SR-20-02M2

Site Plan Review Modification-New Construction
Modify Site Plan
151-199 Solar Street
(aka 127, 163-167, 163-167 Rear, and 171 Solar Street)

WASTE ENCLOSURE EXPANSION CITY SUBMISSION

L3.0

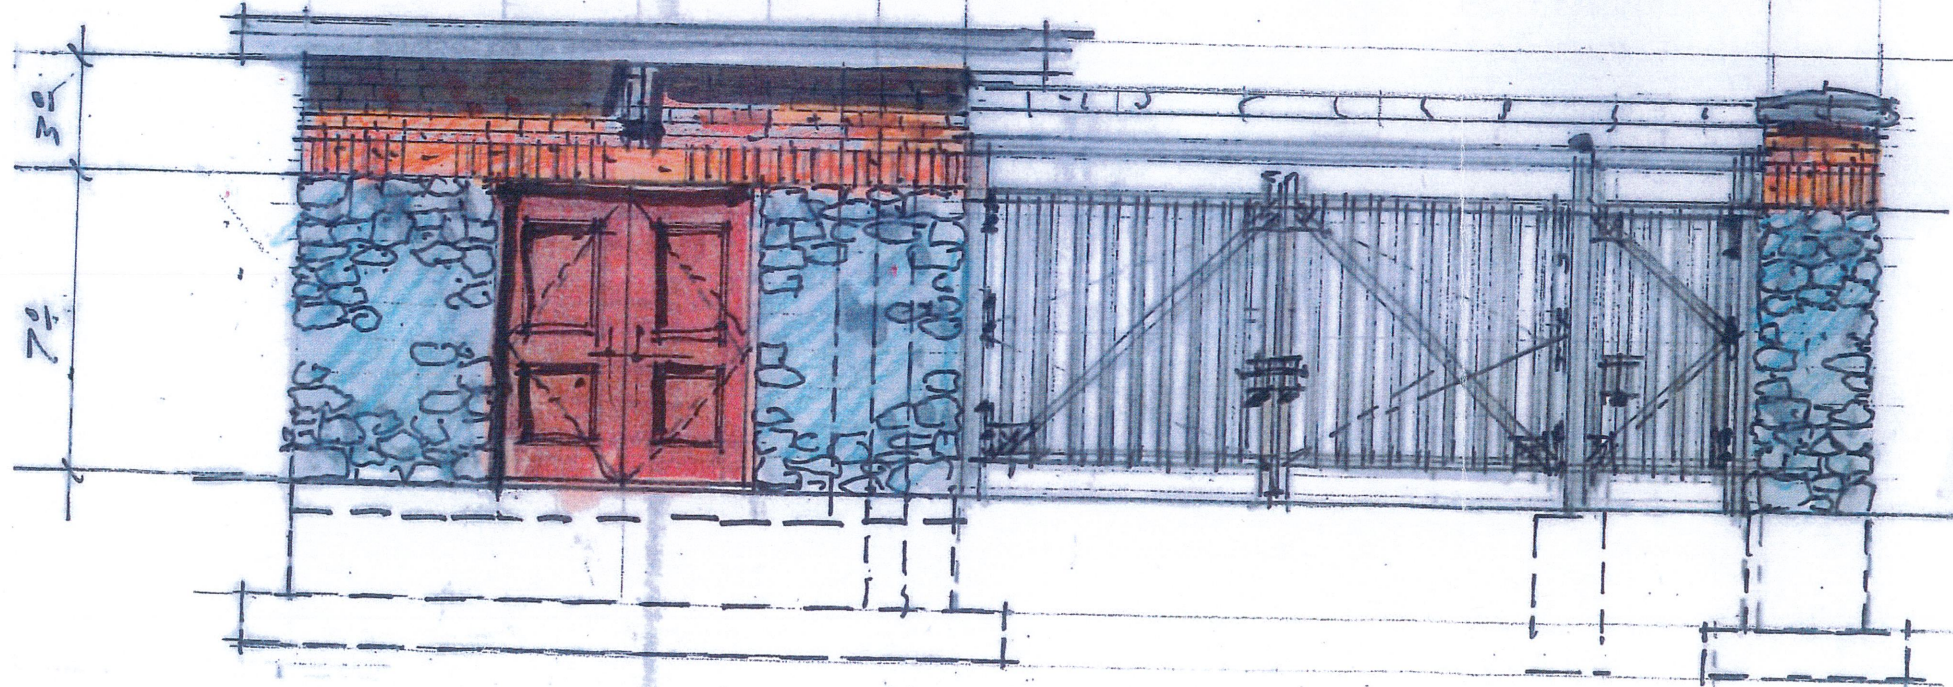
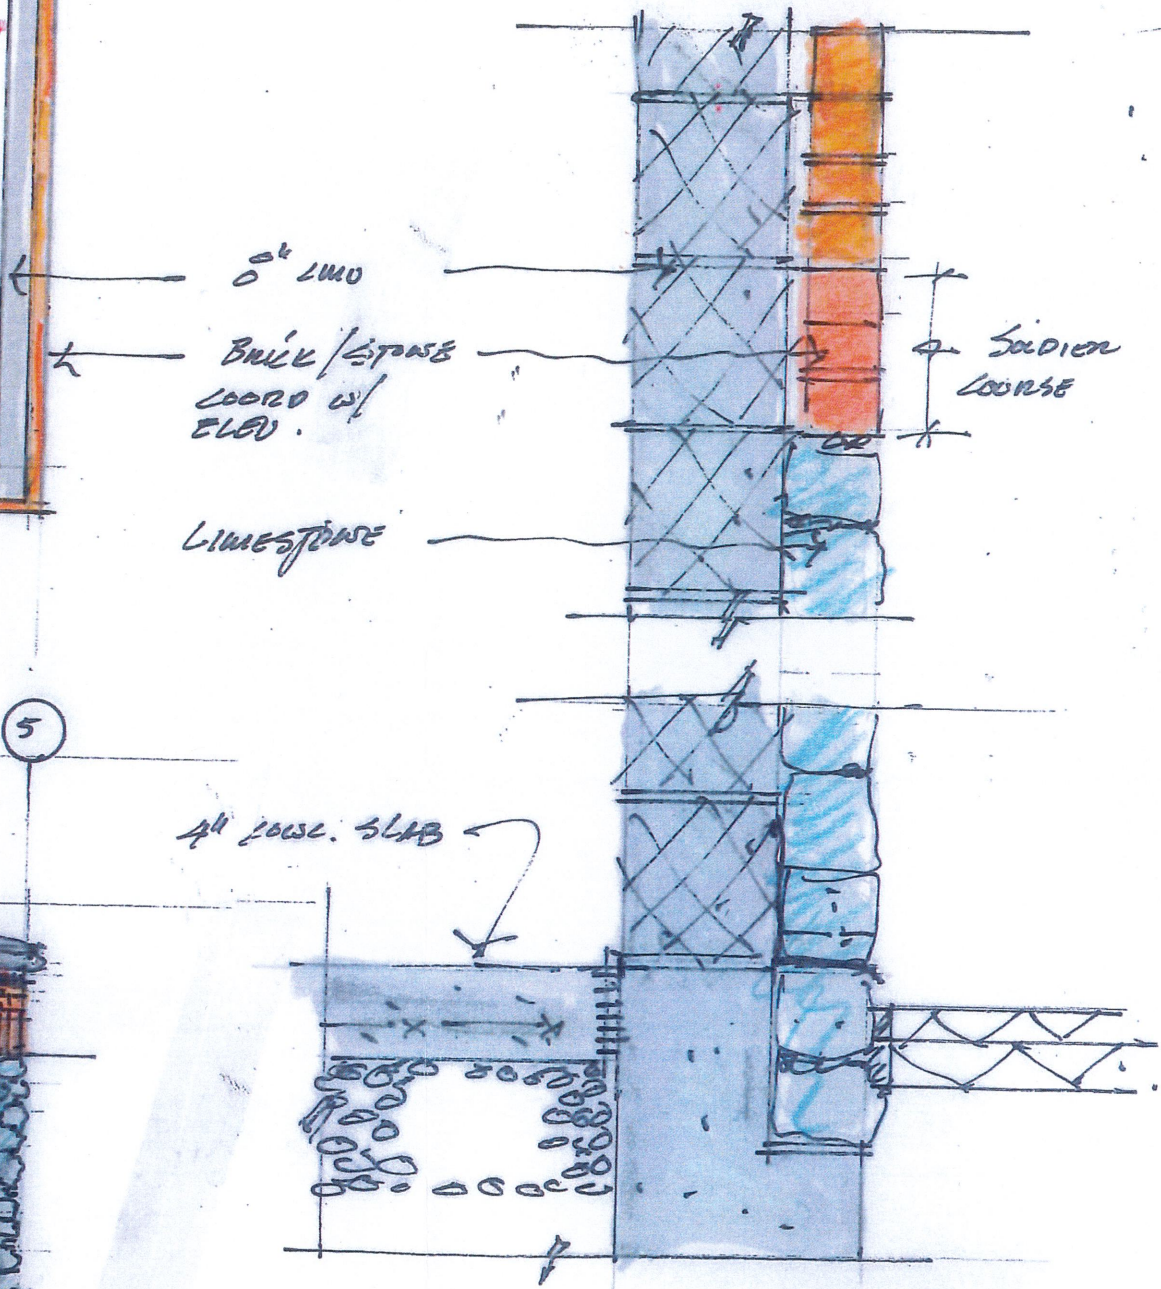
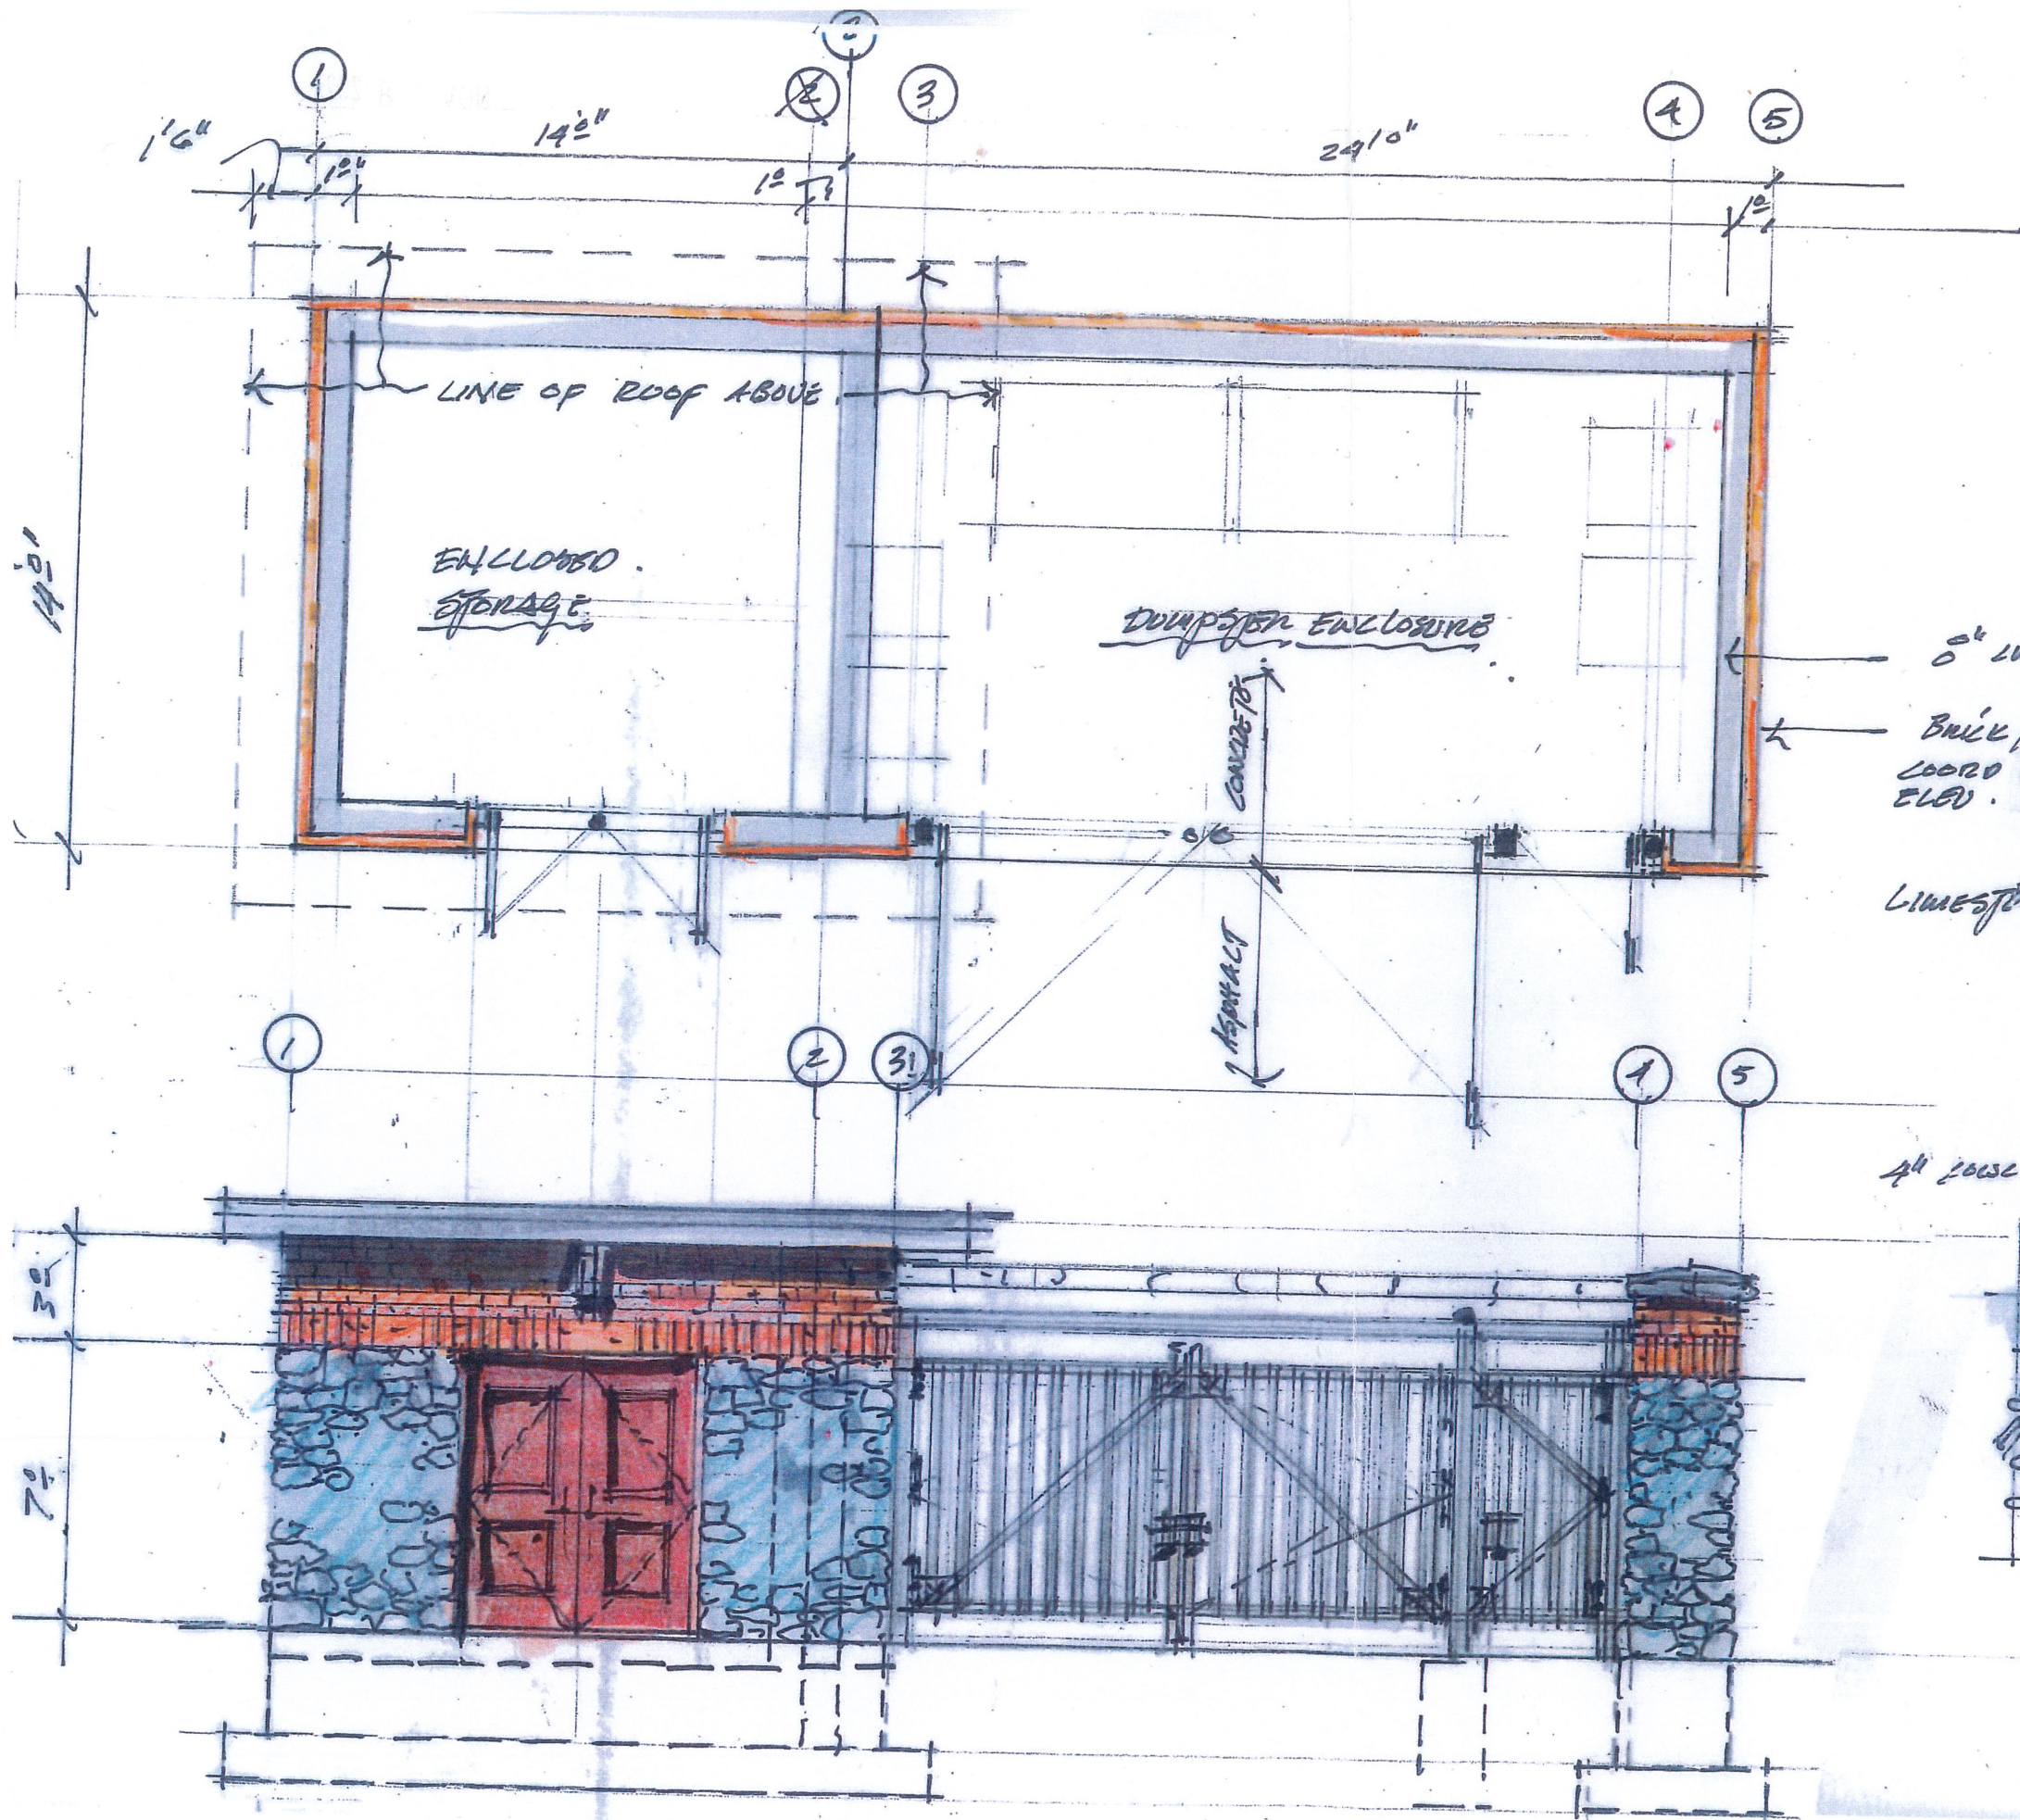
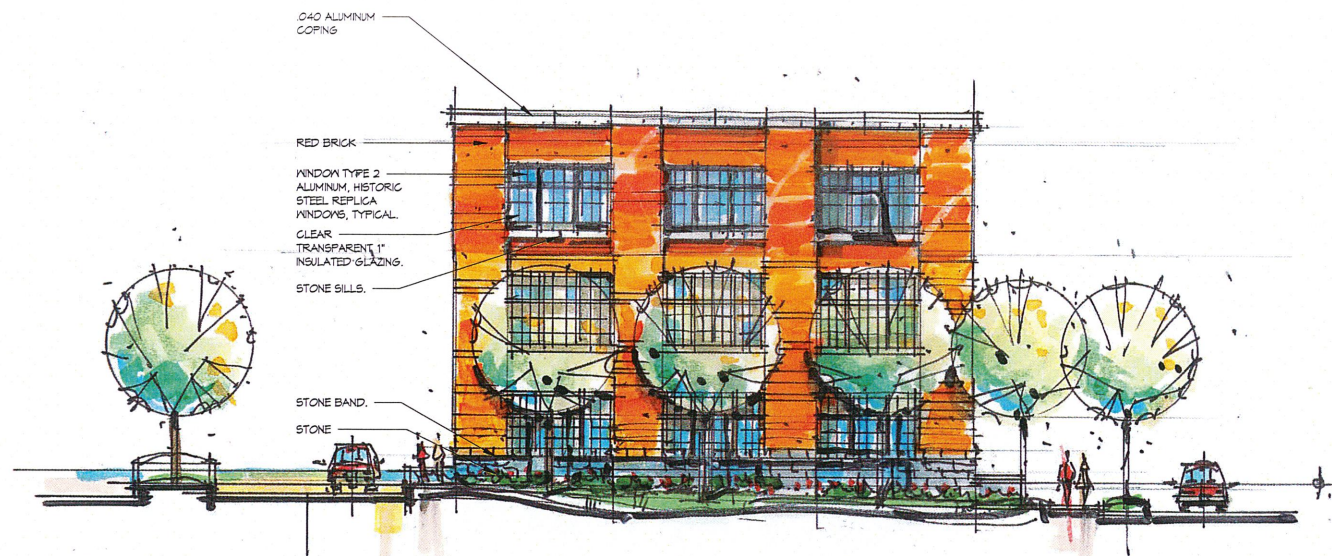
- The proposed revision consists of **constructing a storage shed adjacent to a dumpster enclosure** per the enclosed site plan (Sheet L3.0) and enclosure detail.

Site Plan SR-20-02 to be amended on proposed changes to the previously submitted Site plans. Changes include expansion of approved waste enclosure to add a 14' x 14' covered shed area per architectural plans. Utilities to be extended to shed for power and cleaning.
